| Exhibit Number | : | <u>DRA-9</u>       |

**DIVISION OF RATEPAYER ADVOCATES  
CALIFORNIA PUBLIC UTILITIES COMMISSION**

**Report on the Results of Operations  
for  
Pacific Gas and Electric Company  
General Rate Case  
Test Year 2014**

**Gas Distribution  
Operations and Maintenance Expenses**

15 **Figure 9-1**  
16 **DRA's Proposal for the Cross-Bore Project Scope**

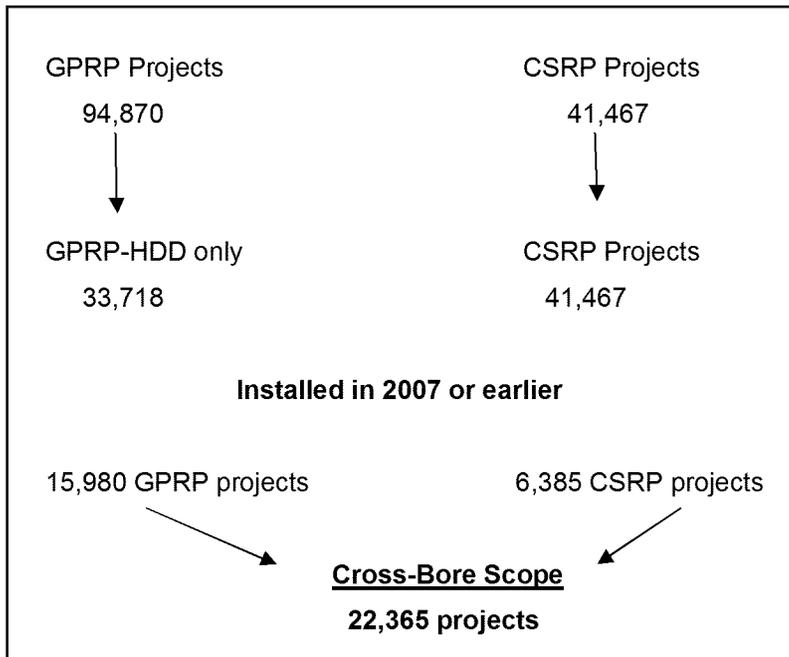
1 PG&E's project scope of 500,000 services is excessive and unsupported.  
2 The totality of projects that should be discussed in this case should only be 22,365  
3 projects as shown in the figure above.
